SERVICE No. 924 BULLETIN

Piper Aircraft Corporation

SUBJECT: Shimmy Dampener Replacement

PA-22-125/135/150/160 Tri-Pacer
PA-22-108 Colt

SKETCH "A"

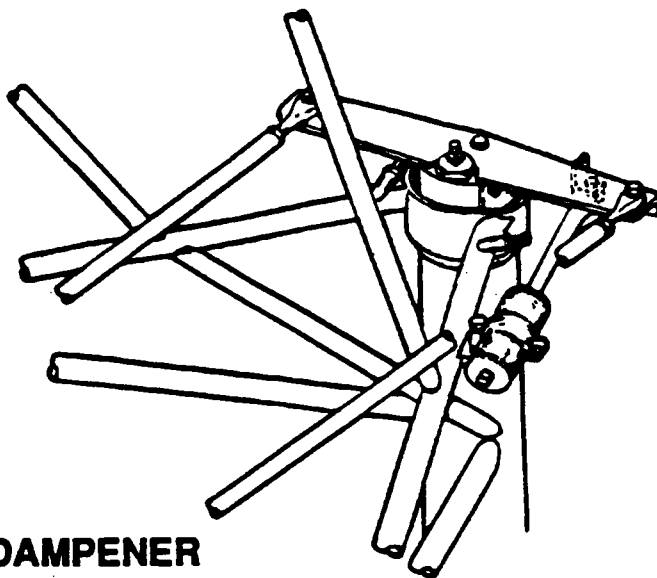
1. Remove cowling as necessary to gain access to nose wheel shimmy dampener. Refer to applicable Owners Manual or Parts Catalog.
2. Shimmy Dampeners with Piper Part Number 13086-00, as identified on Sketch A (attached), should be removed, discarded and replaced by Piper Part Number 21701-06.

This Service Bulletin recommends the shimmy dampener currently installed in the affected model aircraft be replaced by a new Shimmy Dampener, Piper Part Number 21701-06, and provides instructions for continuing maintenance at regular intervals.

SKETCH "B"

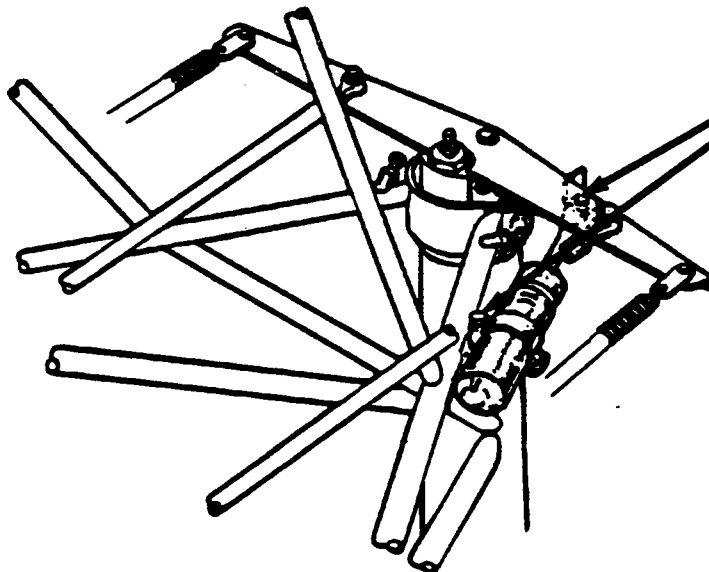
3. If the shimmy dampeners with Piper Part Numbers 21701-02 and 21701-04, Sketch B (attached), are inspected and determined to be serviceable and airworthy and the instructions below are complied with, those shimmy dampeners may be returned to service.

6. Determine that the attachment of the shimmy dampener rod end to the nose wheel steering arm is free to accept angular travel in either direction.
7. Should any stiffness, restrictions, or other maladies be noticed, correct by replacing parts and adjusting as necessary until proper fit and function is obtained.

4. Determine that nose wheel travel is 20 degrees left and right of center.
5. Determine that the shimmy dampener rotates freely on the axis of its attachment bolt throughout its full travel, especially as it approaches the limits of nose wheel travel.

8. A regular maintenance routine of inspection, cleaning, and lubrication should be performed at each one hundred (100) hours of operation or at any inspection event. Lubricate shimmy dampener rod end and pivot point using general purpose low temperature oil (MIL-L-7870 or equivalent). Wipe shimmy dampener shaft using a clean cloth saturated with MIL-H-5606 hydraulic fluid.
